Rezoning Transportation Analysis

Petition Number: 2021-154

General Location Identifier: 14325102

Date	Description
12-28-2021	First Review (KP)
01-27-2022	Second Review (KP)

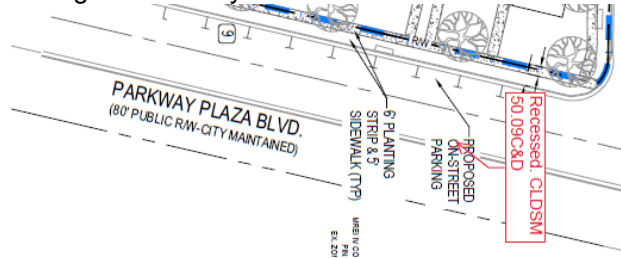
3. ~~Revise site plan and conditional note III.d to commit to construct an 8-foot planting strip and 6-foot sidewalk along the site's frontage of Price Lane and Parkway Plaza Boulevard. The site plan shall label and dimension both items from the back of curb and gutter and road centerline.~~

d. The Petitioner shall construct a minimum of six (6) foot wide planting strip and five (5) foot wide sidewalk along the Site's frontage of Price Lane as generally depicted on the Rezoning Plan.

PROPOSED ZONING:	UR-2
EXISTING USES:	NT
PROPOSED USES:	E-FAMILY ATTACHED (TOWNHOMES)
PROPOSED DEVELOPMENT:	90 UNITS (82 SHOWN)
MAX. BUILDING HEIGHT:	45 FT PER ORDINANCE STANDARDS
OPEN SPACE:	AS REQUIRED PER ORDINANCE STANDARDS
PARKING:	AS REQUIRED PER ORDINANCE STANDARDS

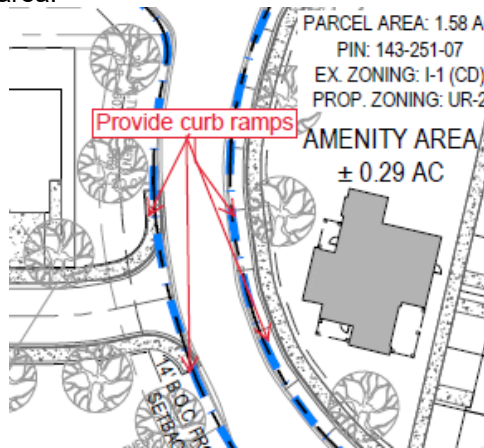
5. ~~Revise the site plan by showing the missing 8 townhomes.~~

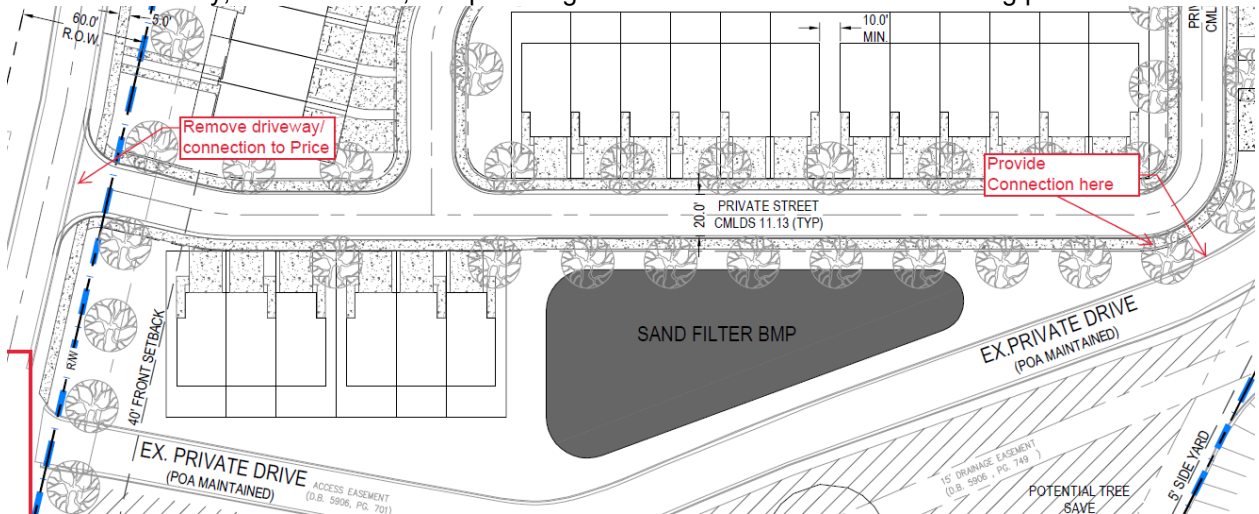
6. ~~Revise the site plan to commit to provide four ADA curb ramps at the proposed private street intersection near the amenity area.~~

7. Revise the site plan by modifying the proposed internal private street network by removing the proposed southern driveway, on Price Lane, and providing an internal connection to the existing private street.

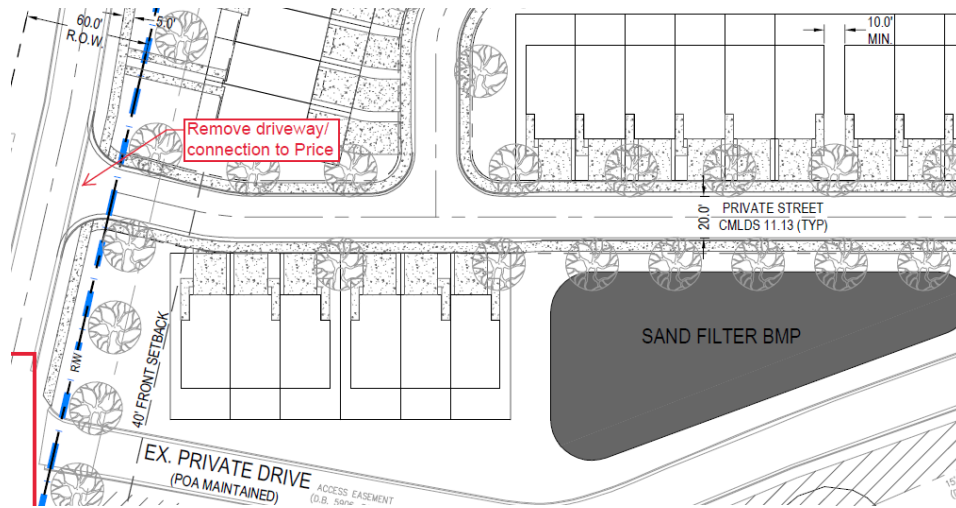
Update to Comment from 01-17-2022 Site Plan: Revise the site plan and conditional note III.b by removing the proposed southern driveway on Price Lane.

b. The maximum number of access points on Price Lane shall be two (2).
